INVITATION OF PUBLIC COMMENTS

विषय: भाराराप्रा - क्षे.का. मदुरै- पकाई, त्रिची - Proposal for erection of 33KV OHT line with 2 Nos. of Baby Tower across the road @ Km 297/200 of NH-38(Trichy - Padalur section) by M/s Sivasakthi Agro Farms, Tiruppur - **Invitation of Public Comments - Reg.**

Sub: NHAI - PIU, TRICHY -Padalur - Trichy section of NH 45 (New NH 38) - Erection of 110/33 KV Electrical Overhead Line with Bay Tower of NH -45 Road (New NH -38) (Padalur - Trichy section) crossing @ Km.297/200 crossing Length 61.2m Total length of 61.2 meter - MoRT&H Application No. 20250730/2/15/40761/18319 dt.31.07.2025- In principle approval Requested - Reg.

Sub : Erection of 110/33 KV Electrical Overhead Line with Baby Tower of NH-45 Road (New NH-38) Padalur- Trichy Section) Crossing at Km 297+300 crossing length 61.02m & Total no of Baby Towers 2 Nos, Total length of 61.2 meter – Concessionaire report – reg.

KM 297/200

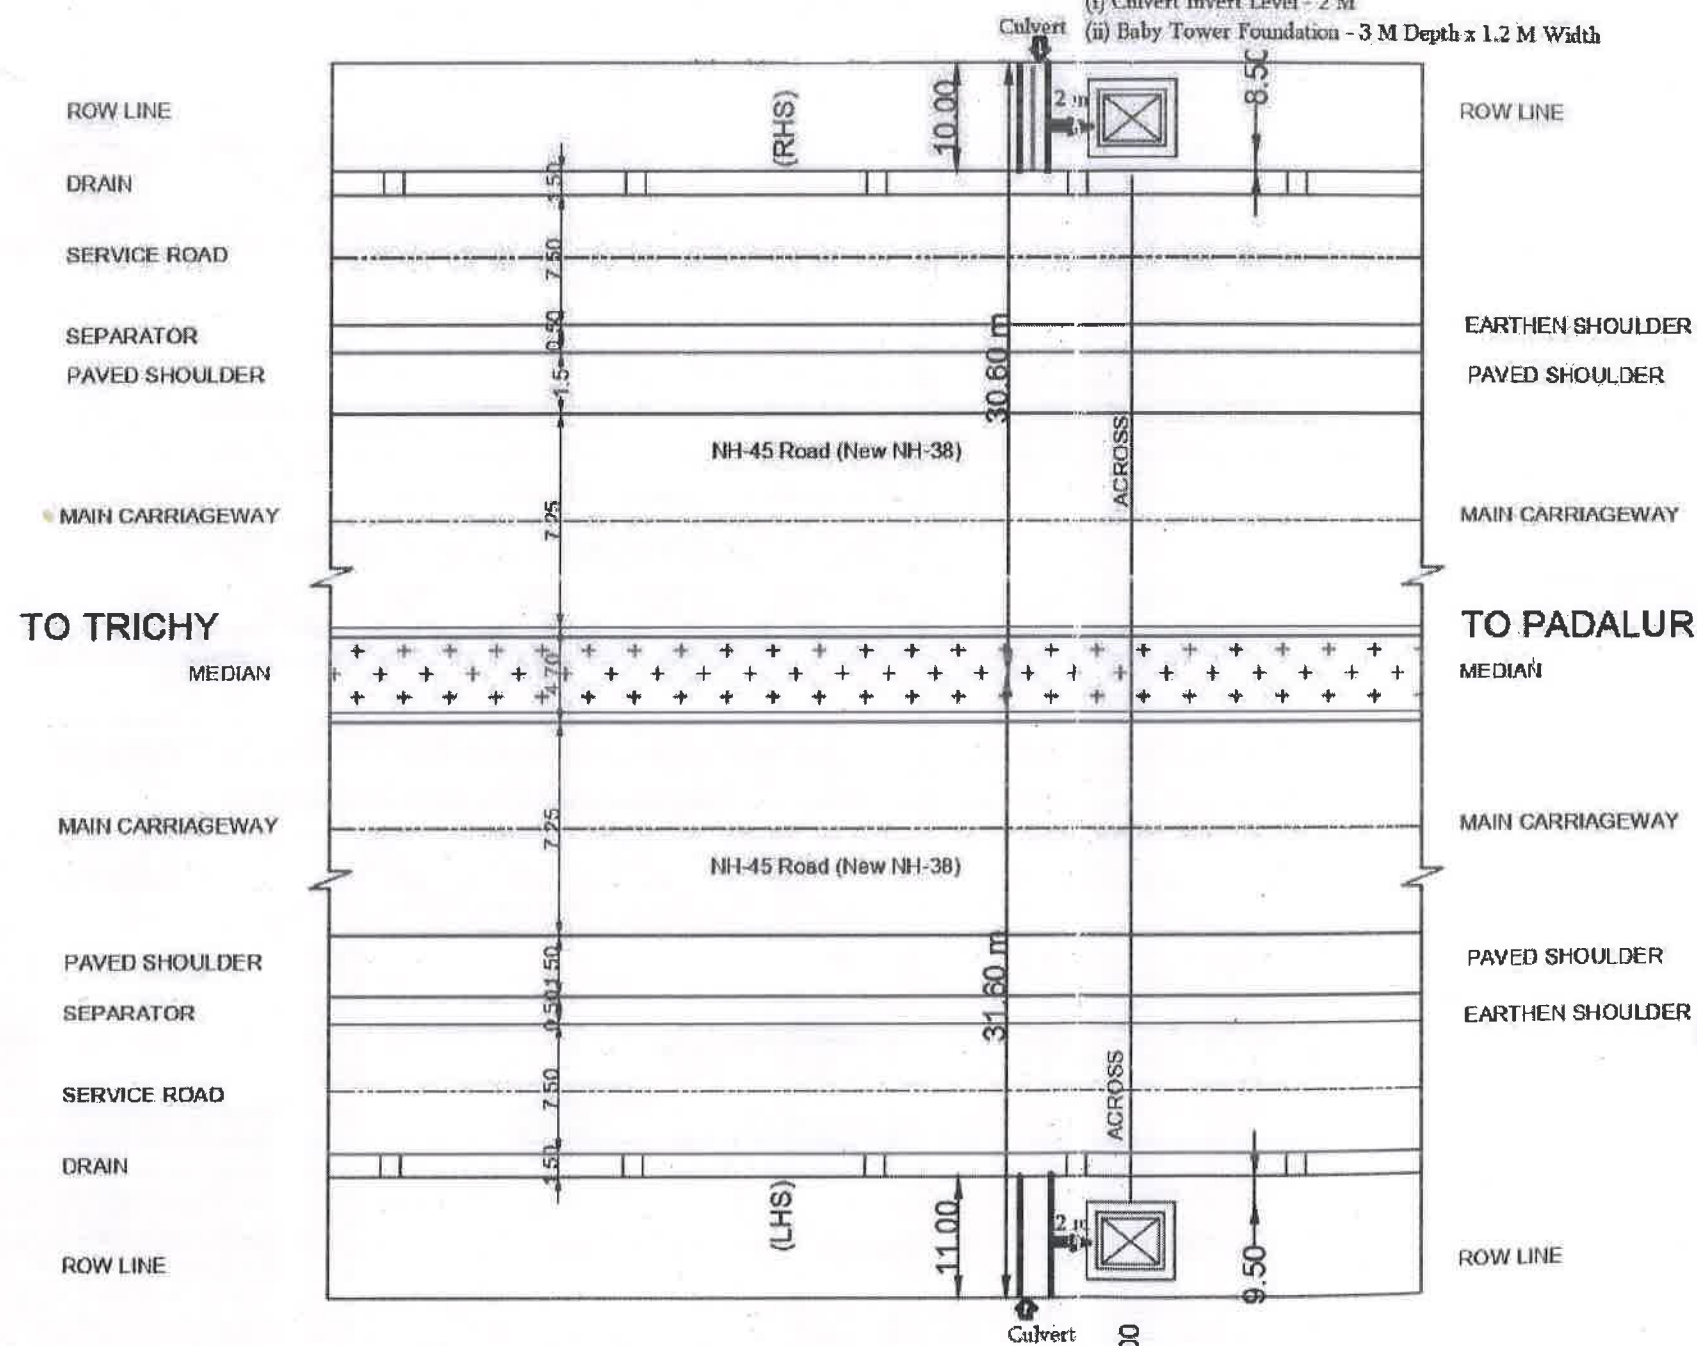
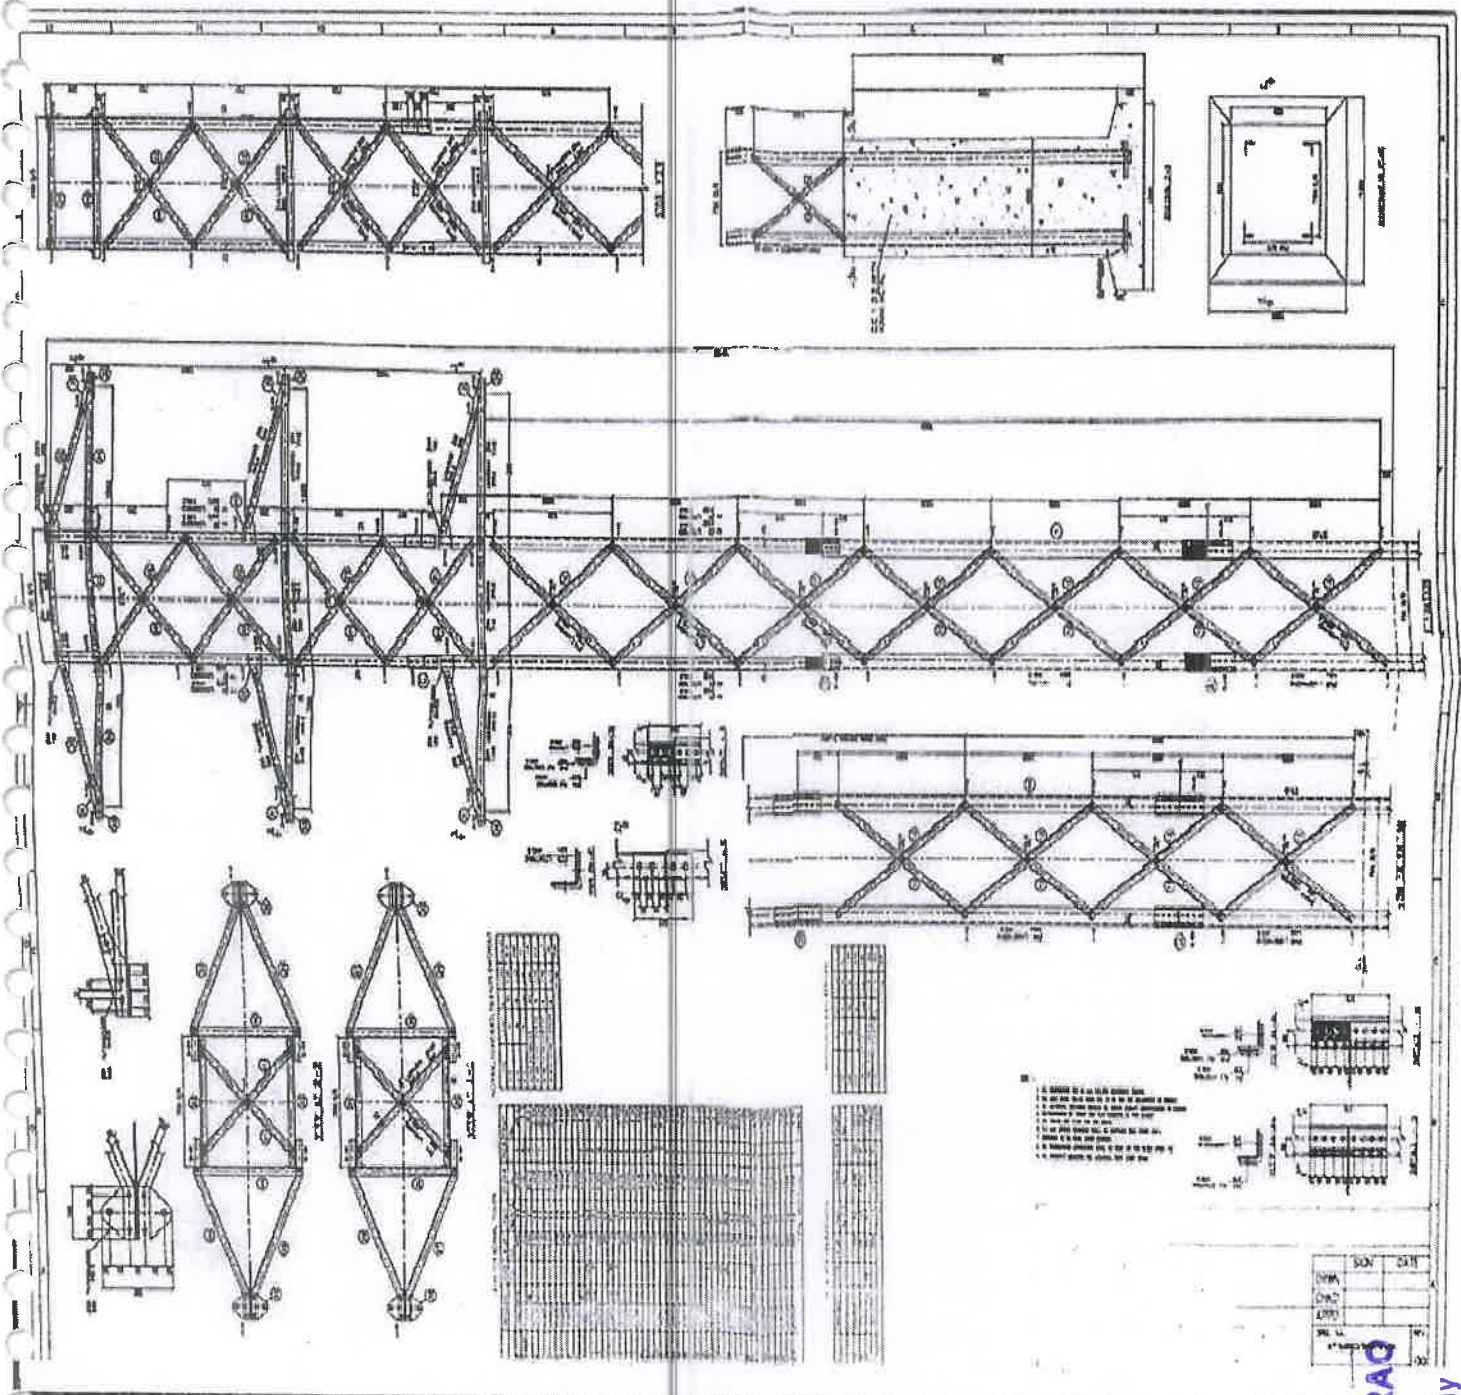
- a- Dimension for baby tower is not found at the drawing submitted by the Applicant. Hence applicant shall be advised to submit the detailed drawing.
- b- Specification of Line Guard is not specified in the proposal. Hence applicant shall be advised to submit the specification to enable us to understand the safety parameters.
- c- Foundation to be made at the edge of boundary as per the drawing.

2. The baby tower drawing details have not been submitted in the proposal. The applicant is advised to submit the detailed drawings of the baby tower and also to mention the overhead guarding line dimensions in the submitted drawings.

[The concrete for the Baby tower foundation must be poured more than 1 meter below the culvert invert level]

(ii) Baby Tower Foundation - 3 M Depth x 1.2 M Width
